Re: PB 87-56 Monterey Shores, Corolla Bay Phase 3
Amended Sketch Plan / Special Use Permit
Multi Family Special Use Permit

Thank you for the TRC review comments, dated June 15, 2023, for the Amended Sketch Plan / Special Use Permit / Multi Family Special Use Permit application for the above referenced Corolla Bay Phase 3 project.

AMENDED SKETCH PLAN

PHASE III CONCEPT SKETCH
MONTEREY SHORES PUD
POPLAR BRANCH TOWNSHIP CURRITUCK COUNTY NORTH CAROLINA

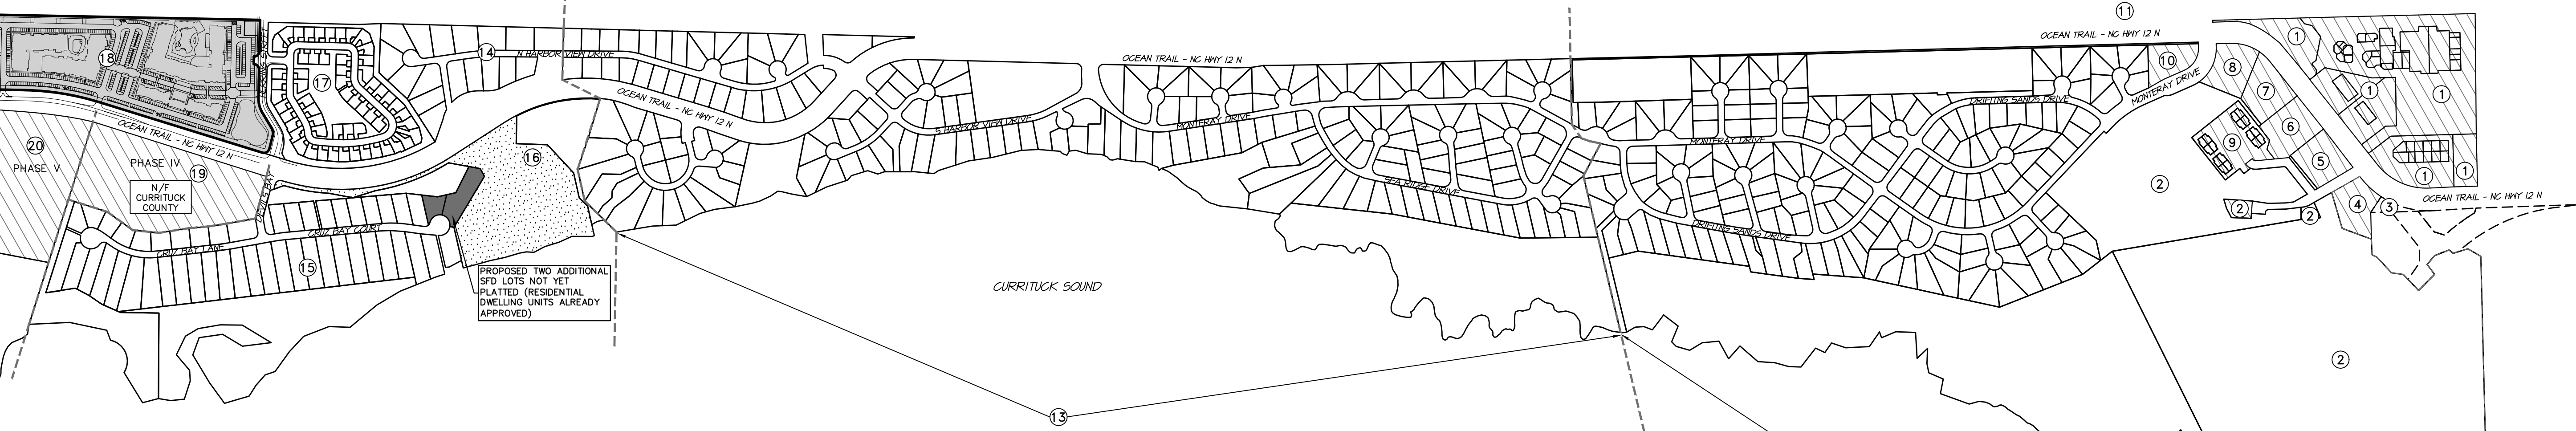
4. After the most recently approved amended sketch plan prepared by Bissell, CAMA wetlands were designated. Please update CAMA wetland area to 43.53 and revise density calculation.

6. Let's discuss the best way to denote the 57 + 26 units under Lot 3 (Villas) on the sketch plan.

Parcel 10 within Map Reference #2 CAMA wetland area has been updated to 9.15 acres per our discussion. Footnote [4] has also been referenced within this column for clarity. The CAMA Wetlands listed within the Summary of Proposed Changes to Development Data With Current Amendment have also been updated to 43.53 acres per our discussion; which also required updating the Net Developable Area and Residential Density (both of which propose no further changes).

Per our discussion, the number of residential dwelling units for Map Reference #17 has been updated to 57, and the previously shown additional 26 relocated to Map Reference #16 (separately as 10+24 along the Section 2 Lot 2 row, and 2 for Section 2A future development parcel).

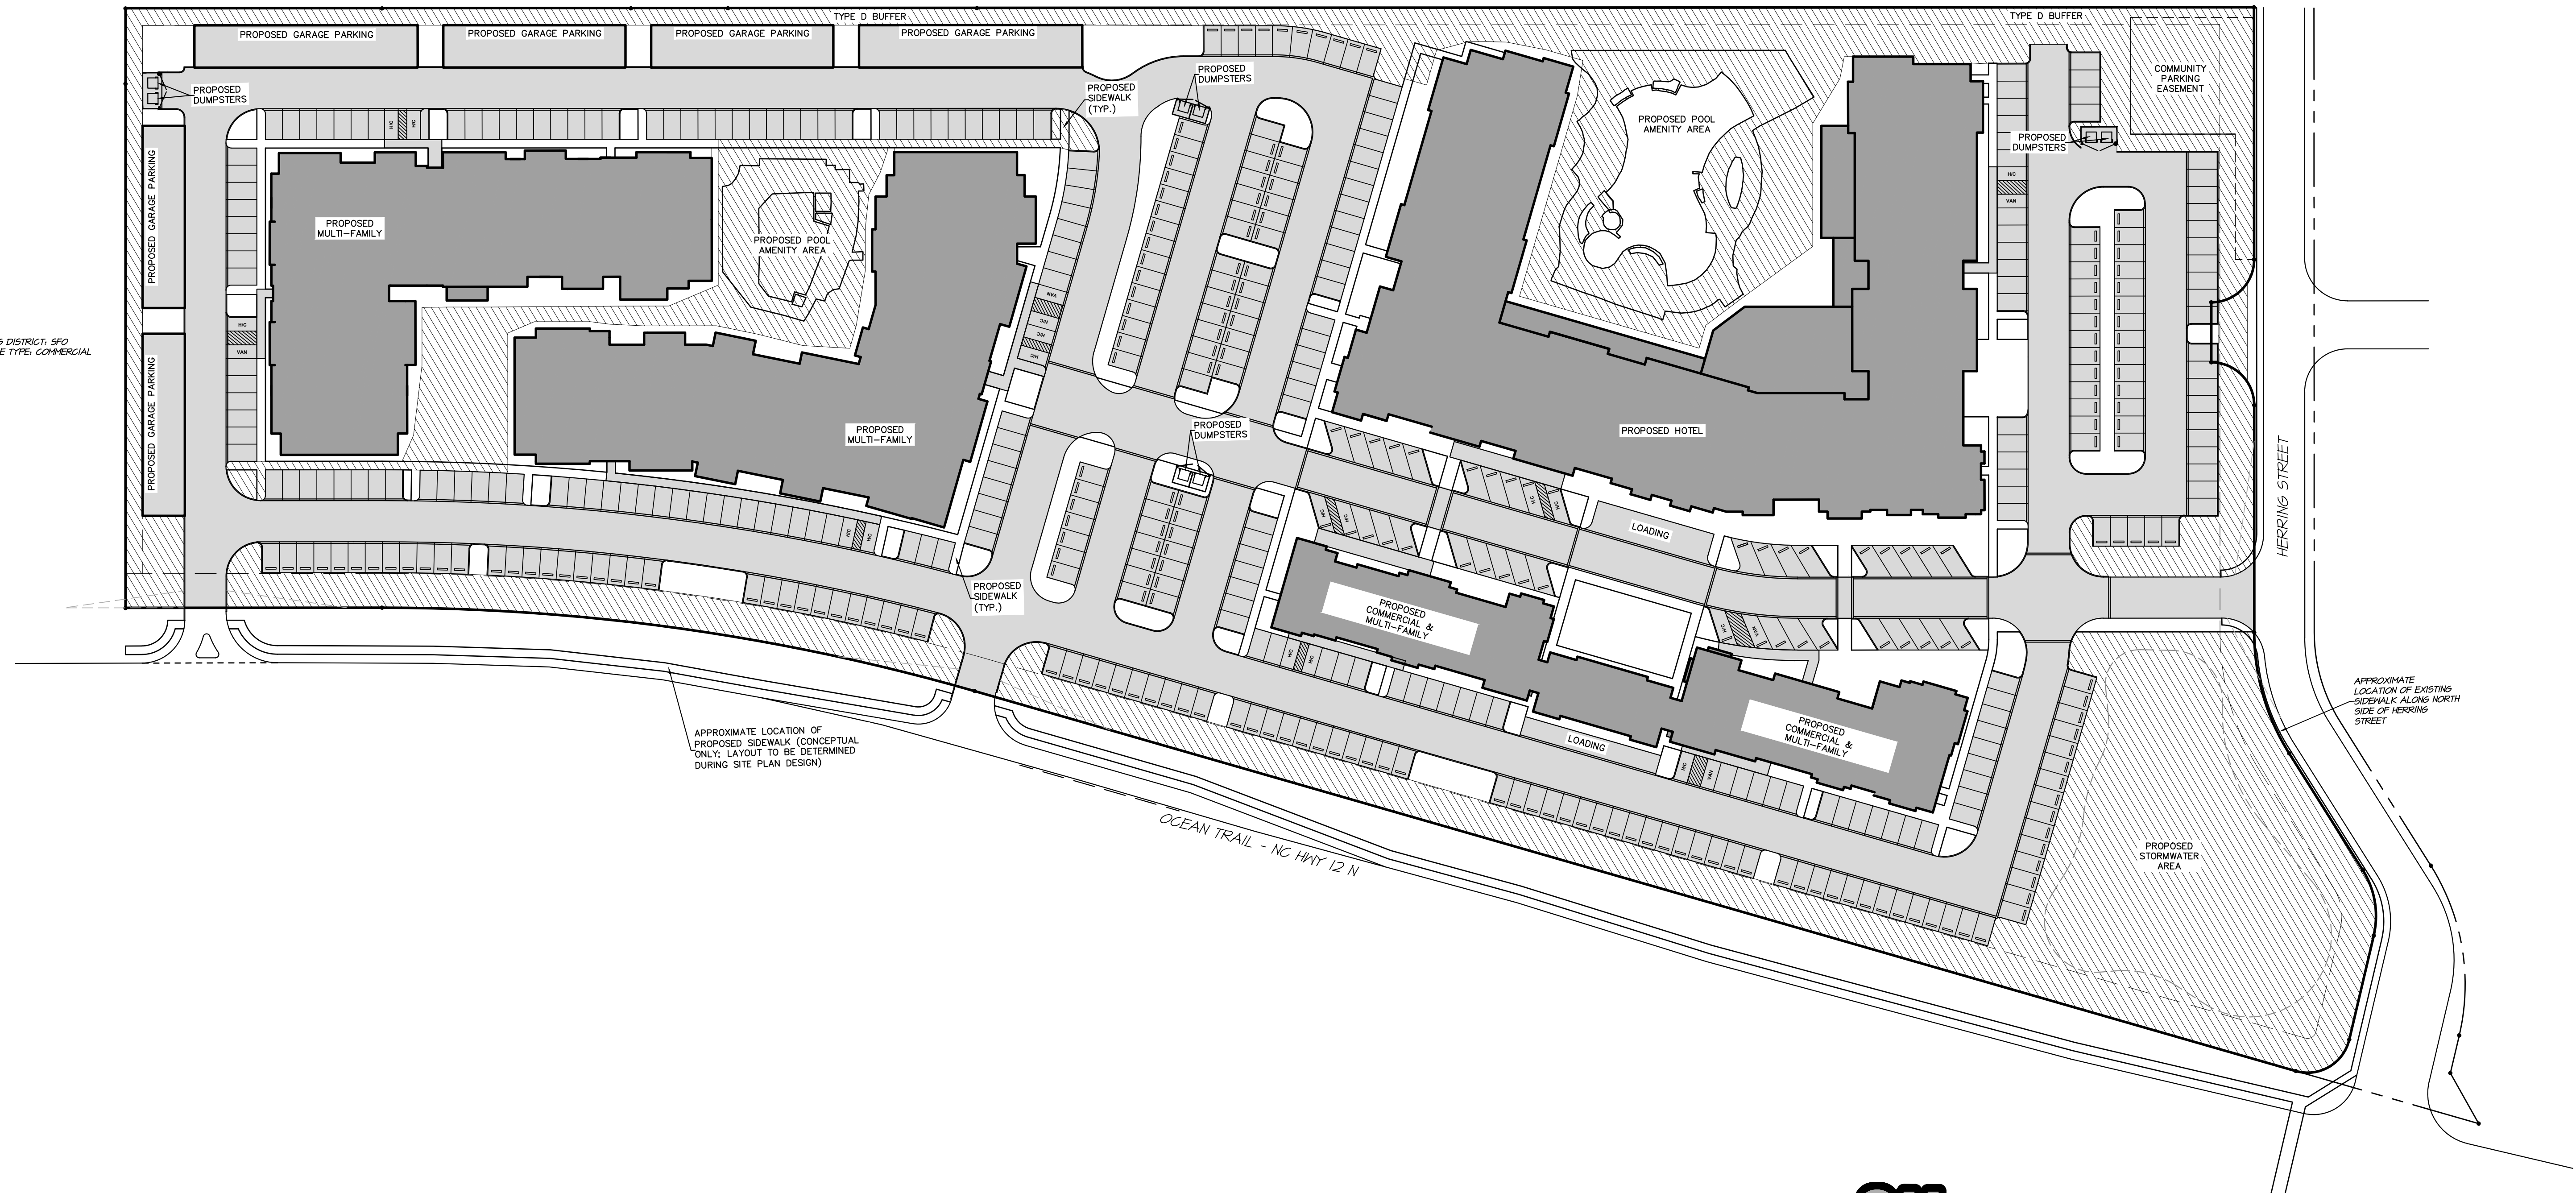
10. Please update the conceptual plan to include all items on design standards checklist.

12. Provide general parking schedule and review preferred parking locations of Community Compatibility Standards. Provide a Type D buffer for parking adjacent to SFDs.

13. A loading space is required.

14. Refuse collection facilities shall not be located between a principal structure and any adjacent streets and shall be located at least twenty feet from any lot line shared with a lot containing a single-family dwelling.

18. Provide sidewalk along NC12 for consistency with Connect Currituck Pedestrian Plan.

The above referenced information has been incorporated into the conceptual development plan shown on sheet 2 of the amended sketch plan to the best of our ability at this time. Please continue to keep in mind that conceptual development plan is diagrammatic only and will change as site plan develops during major site plan design phase, while provisions of the UDO shall be met.

A conceptual general parking schedule is offered below. Actual parking requirements will be determined and complied with during site plan design.

In addition, Type D buffers are shown on the ASP for parking adjacent to SFDs.

Loading spaces have been shown on the enclosed conceptual development plan, but will be further considered and refined during major site plan design phase.

Acknowledged; locations of refuse facilities have been updated on the enclosed conceptual development plan. Refuse locations will be further evaluated during major site plan design phase.

A proposed walk has been shown conceptually along the east side of NC Hwy 12 on the enclosed conceptual development plan to compliment the existing walk along the north side of Herring Street. Actual configuration of these walks will be given further consideration during major site plan design phase to ensure aesthetics and harmony with the development plan.
